**PREFERRED PROJECT REPORT
MAJOR PROJECT APPLICATION NO. 08_0234**

"RISE" BILAMBIL HEIGHTS

PREFERRED PROJECT REPORT

3.1 Department of Planning – 22 October 2009

PLAN OF PROPOSED ZONES
BASED ON TWEED LEP 2008
FOR RISE CONCEPT PLAN
(ON MGA TRUE)

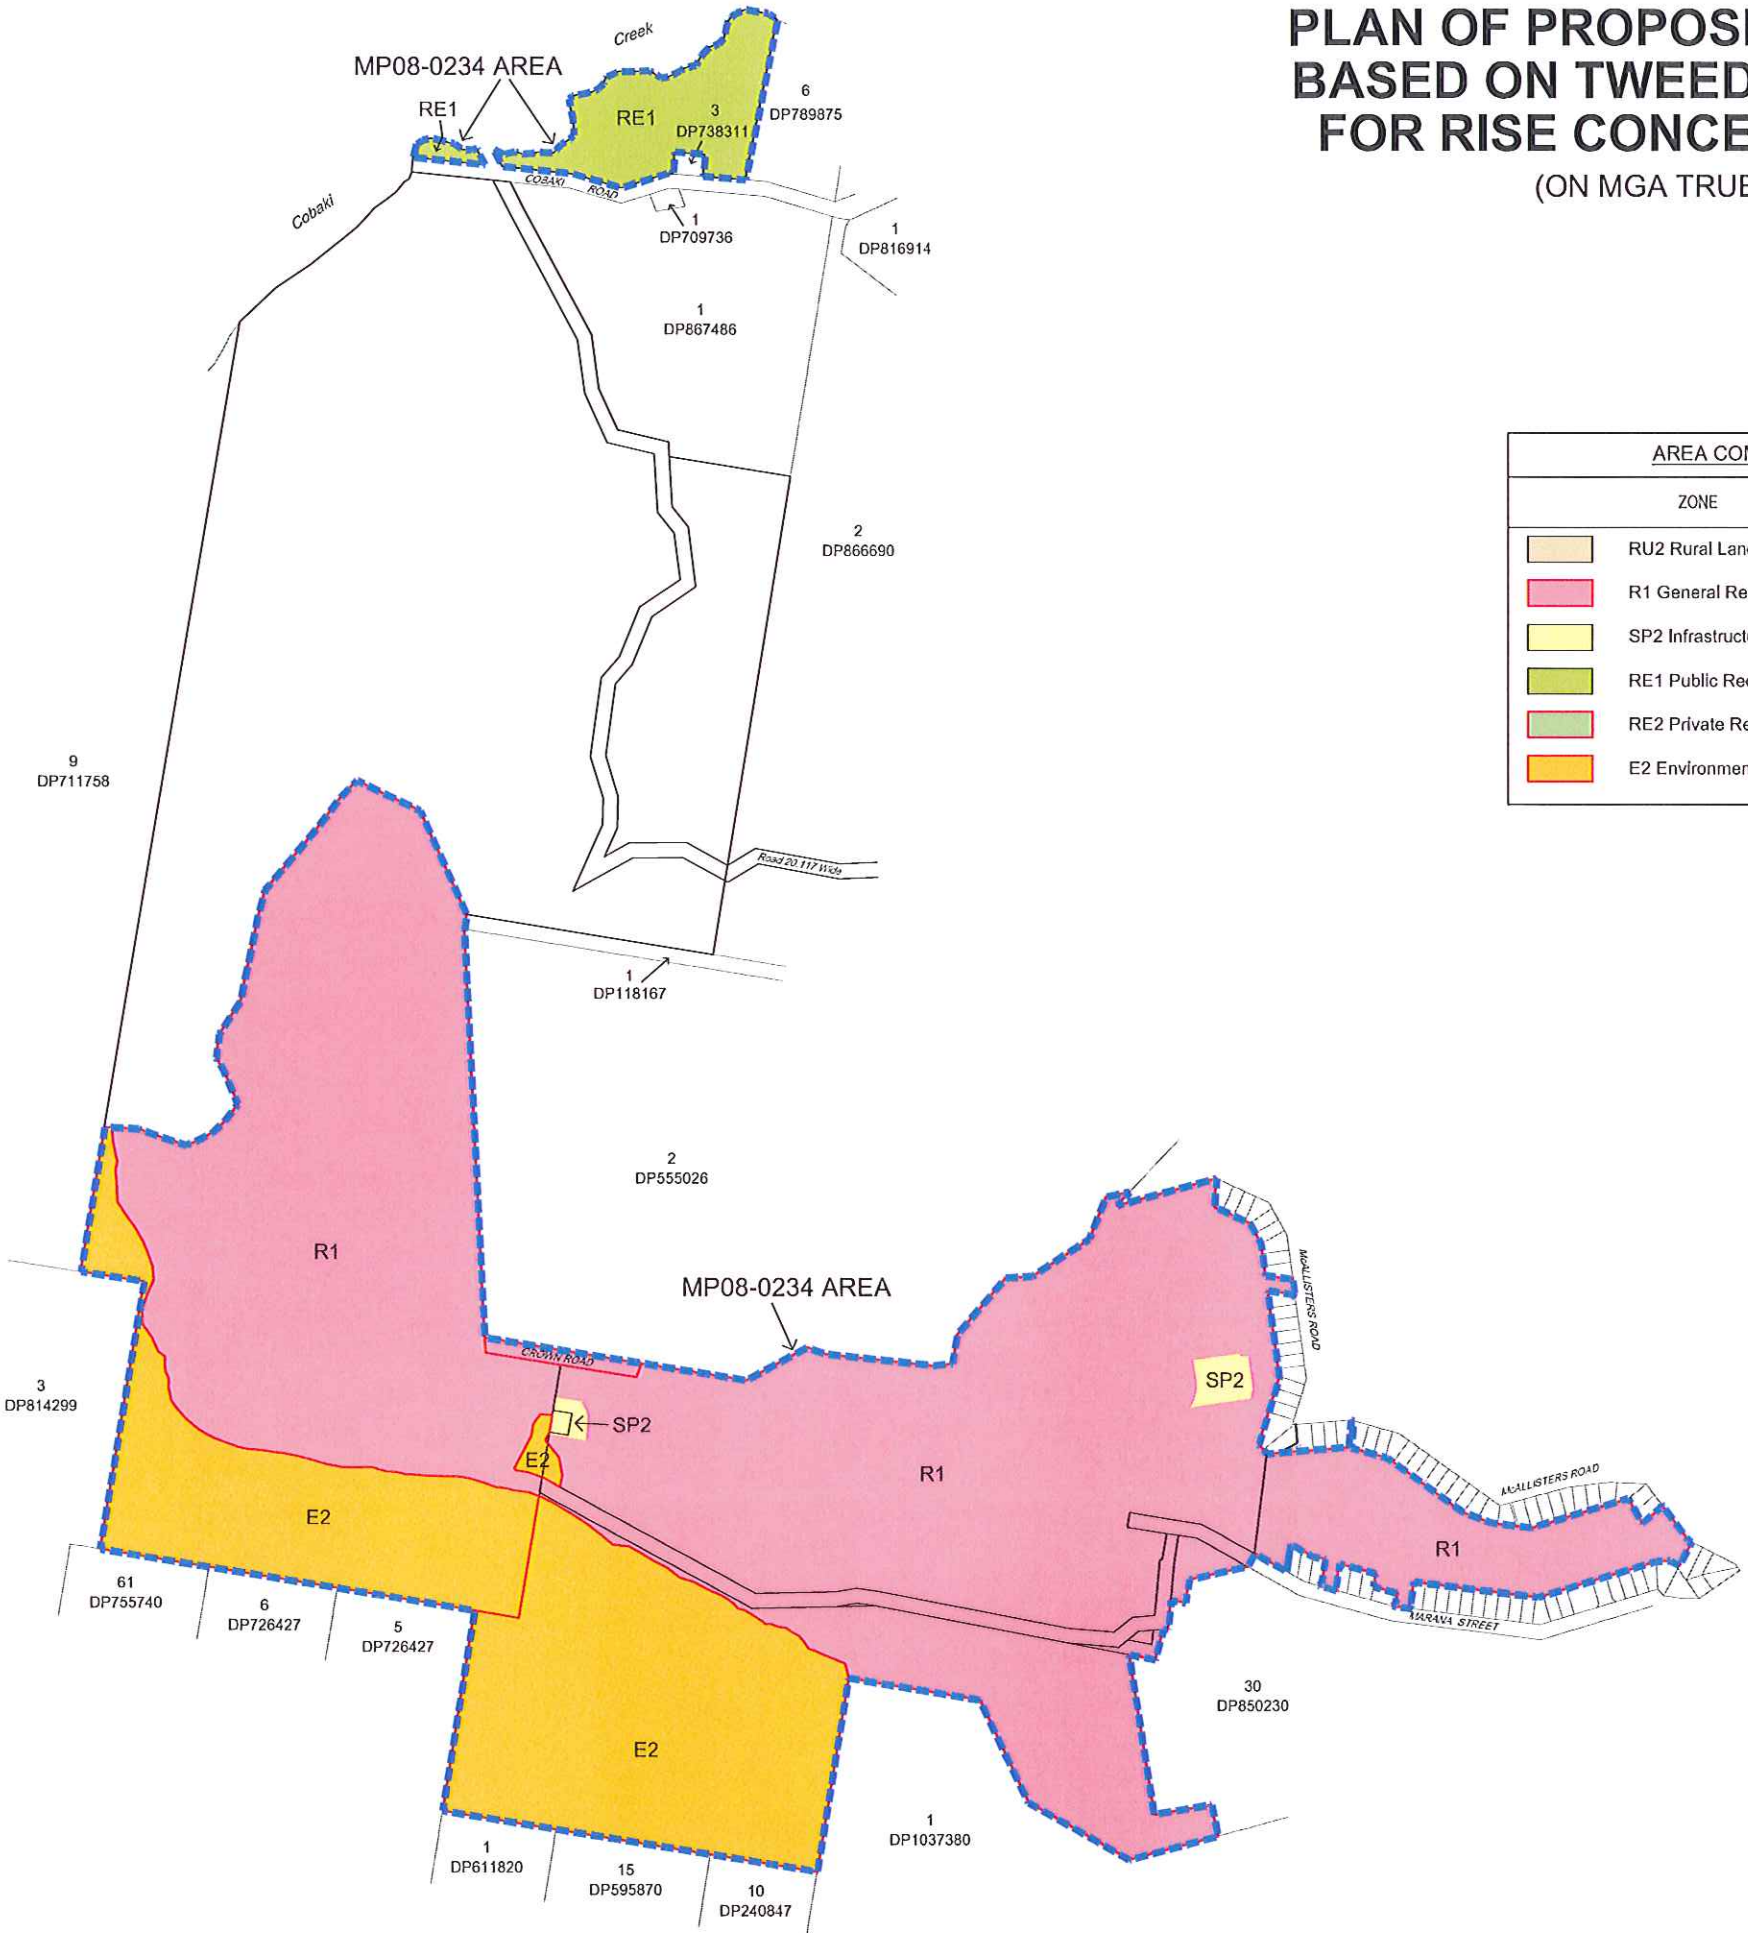
D	PRECINCT J TO E2 ZONE	GL 1/12/2009
C	SCALED TO MGA TRUE @ SSV59056	GL 2/9/2009
B	STAGE 2 REMOVED	AS 2/7/2009
A	SP2 Added	GL 24/4/2009
ISSUE		SUBJECT
AMENDMENTS		BY DATE
